**MONTGOMERY COUNTY HISTORIC PRESERVATION COMMISSION**  
**STAFF REPORT**

<b>Address:</b>	10304 Montgomery Avenue, Kensington	<b>Meeting Date:</b>	6/12/2024
<b>Resource:</b>	Primary Resource <b>Kensington Historic District</b>	<b>Report Date:</b>	6/5/2024
<b>Applicant:</b>	Jeff and Gloria Capron (Luke Olson, Architect)	<b>Public Notice:</b>	5/29/2024
<b>Review:</b>	Historic Area Work Permit	<b>Tax Credit:</b>	No
<b>Permit Number:</b>	1060765 REVISION	<b>Staff:</b>	Chris Berger
<b>PROPOSAL:</b>	Enlarged areaway and fenestration alterations.

2 PROPOSED RIGHT SIDE ELEVATION  
SCALE: 1/8"=1'-0"

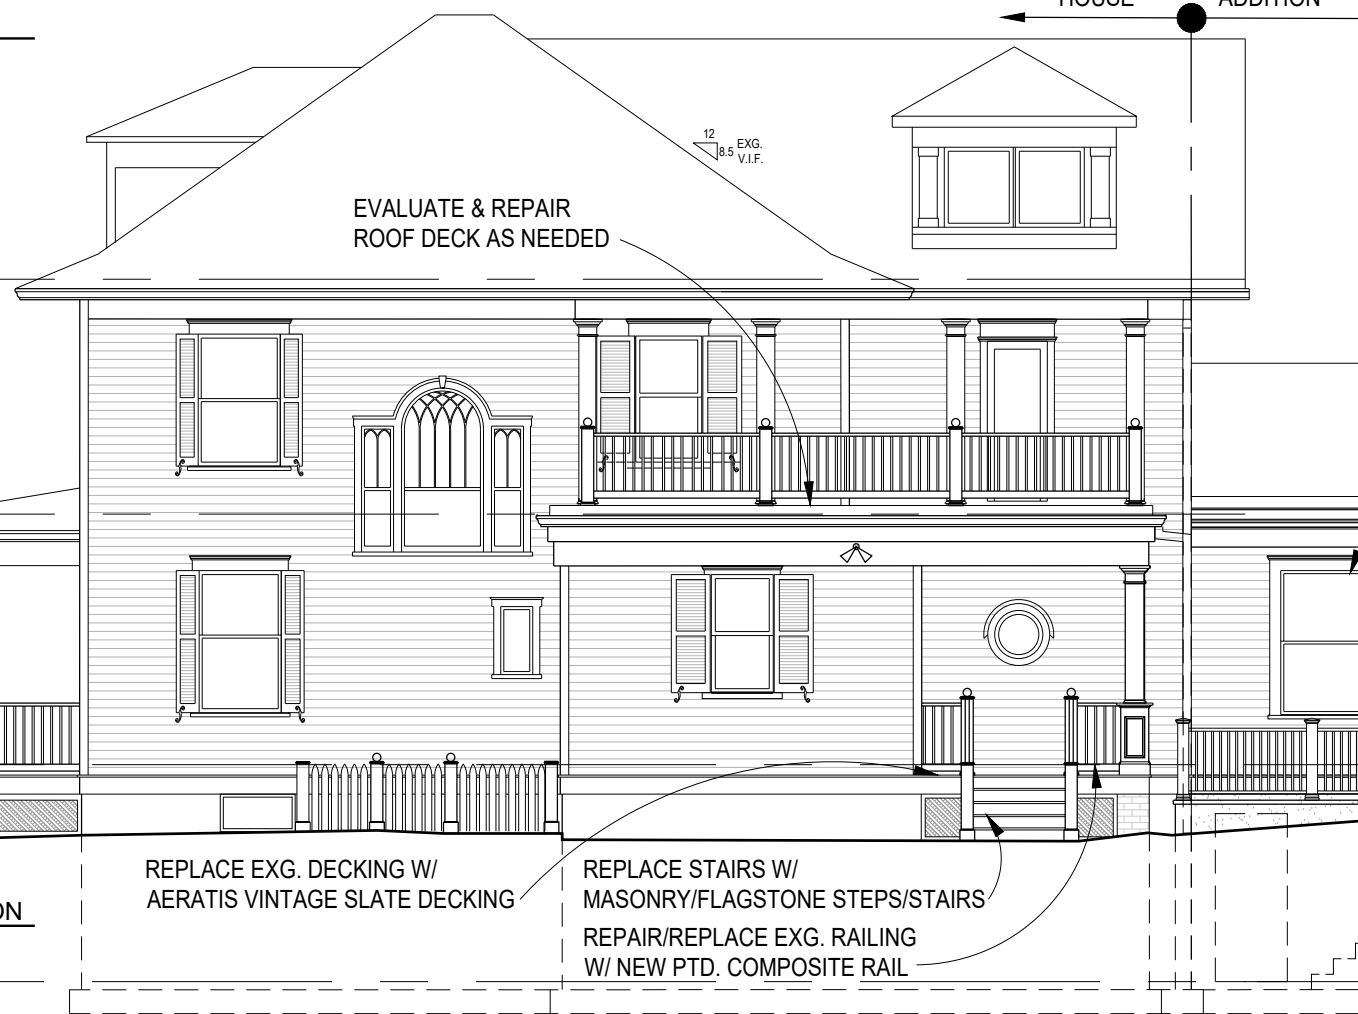
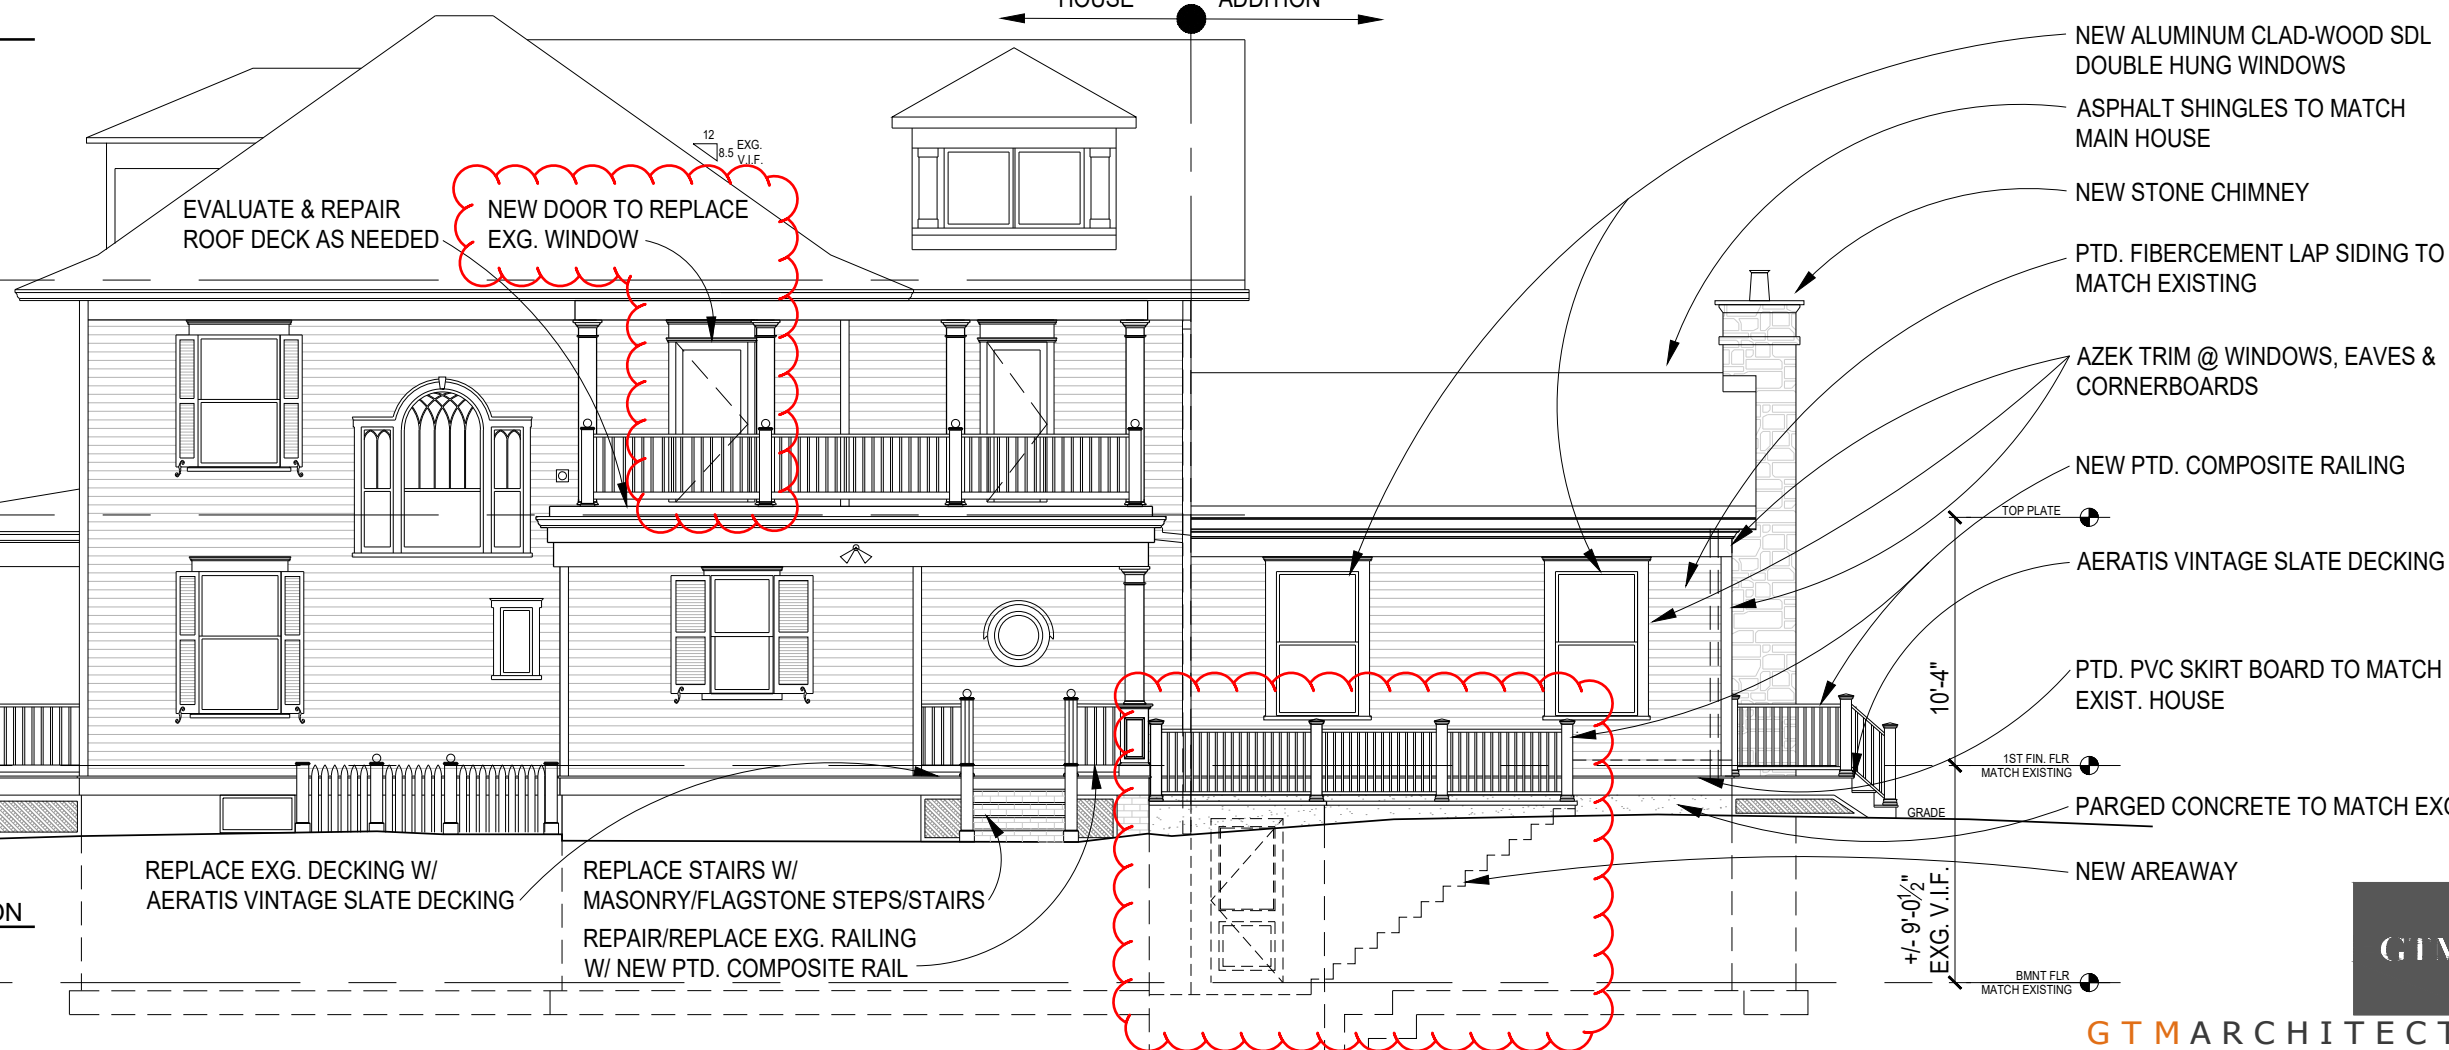
-we noticed a discrepancy in our HAWP approval set in that we were showing a new door onto the 2nd floor roof deck in the approved 2nd floor plan but that wasn't reflected in the right-side elevation. We've provided an updated elevation for review.

2 PROPOSED REAR ELEVATION  
SCALE: 1/8"=1'-0"

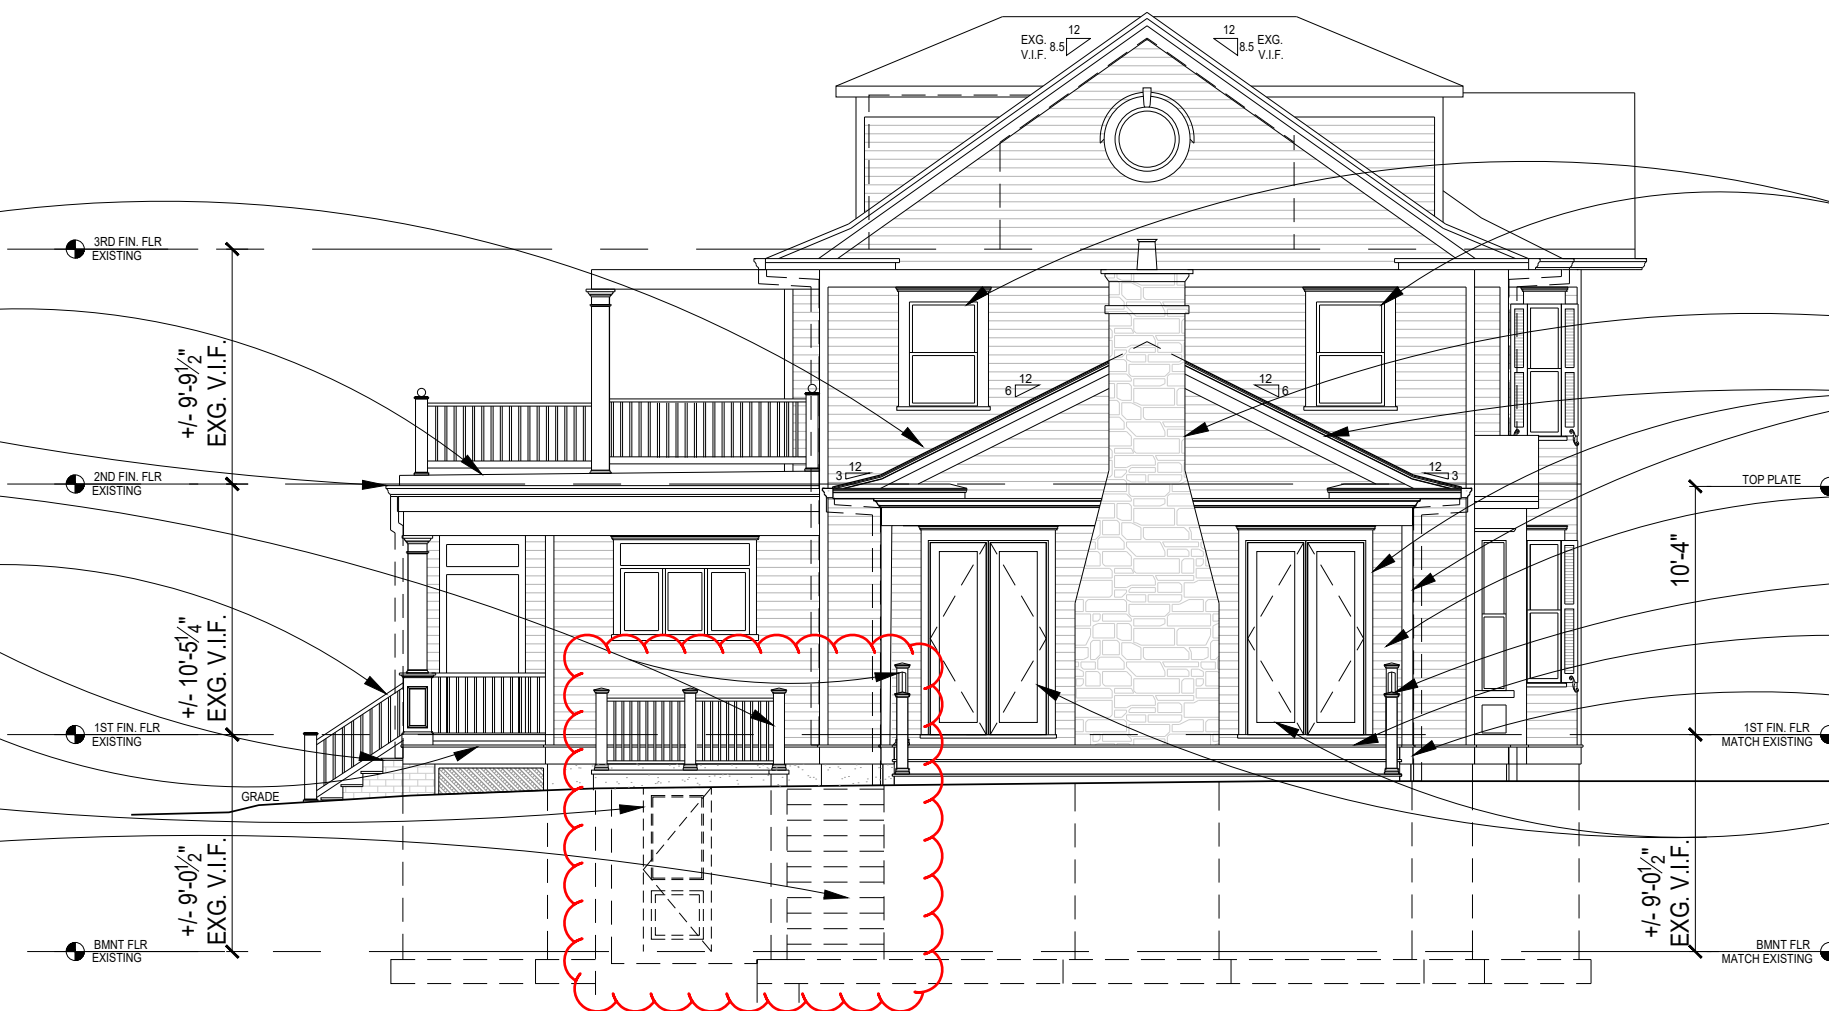
NEW DOOR TO REPLACE WINDOW WELL IN PROPOSED AREAWAY
